10 Mb/s Single Twisted Pair Ethernet 10BASE-T1L Changes

Steffen Graber
Pepperl+Fuchs

PHY Control State Diagram Changes

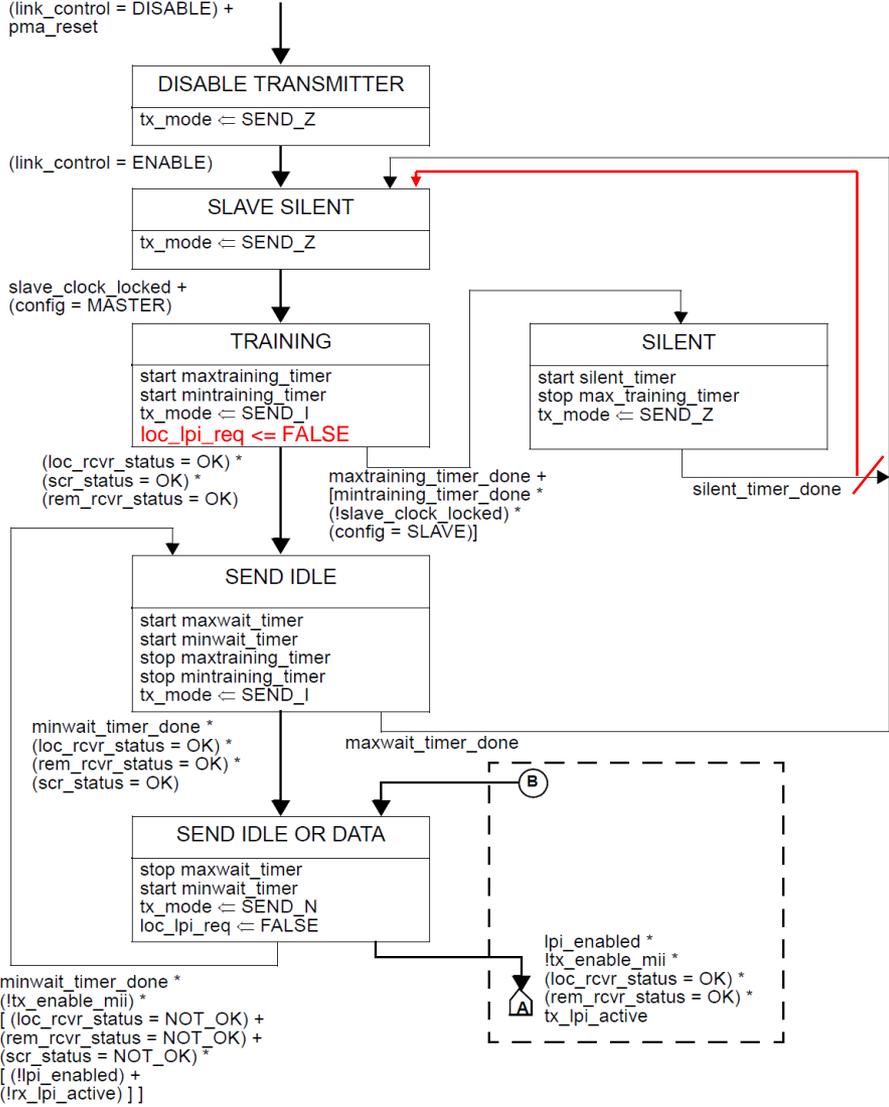
- Move arc of SILENT state exit condition directly to SLAVE SILENT state (editorial style correction).
- Initialize “loc_lpi_req” variable the first time the PHY starts to transmit data (otherwise having “loc_lpi_req” uninitialized the remote PHY may accidentally initially be signaled to go into LPI mode).
- This is necessary because “loc_lpi_req” is used in the PCS scrambler definition, which can change the SEND_I encoding used in SEND IDLE.”

PCS Receive State Diagram Changes

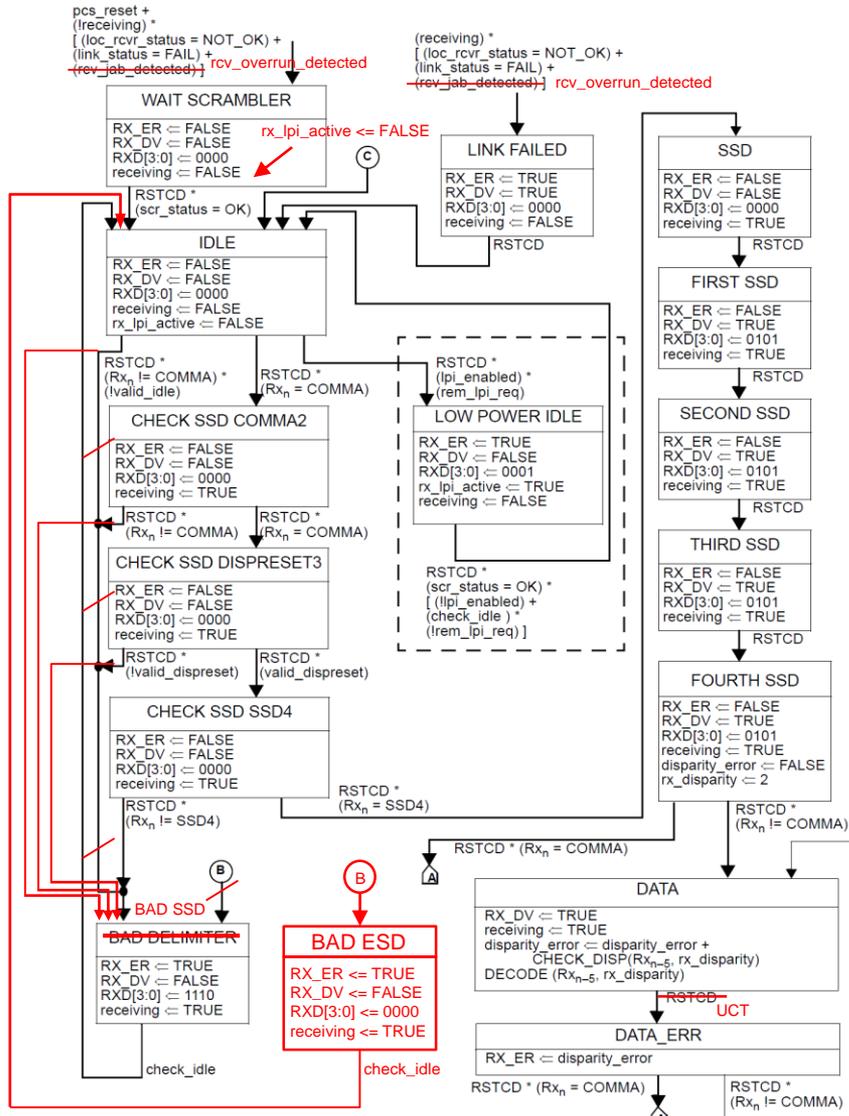
- Variable “rx_lpi_active” needs to be initialized at the beginning of the state diagram. This variable is used by PMA Receive, which otherwise could accidentally switch the receiver into low power idle state.

- Currently reception of a bad SSD as well as a bad ESD both ends up in BAD DELIMITER state. Within this state a False Carrier Indication is signaled over the MII.

- A False Carrier Indication in other IEEE802.3 clauses is only provided when receiving a bad SSD encoding, not a bad ESD encoding.
- Thus the BAD DELIMITER state needs to be splitted into two separate states: BAD SSD, which is executed when receiving a bad SSD and thus providing a False Carrier Indication over the MII and BAD ESD, which is executed when receiving a bad ESD and thus not providing a False Carrier Indication over the MII.

- Change variable name “rcv_jab_detected” to “rcv_overrun_detected” (this was missed in D3.0).
- Change the “RSTCD” condition to an “UCT” condition between DATA and DATA_ERR states,

- The other changes are related to editorial style.
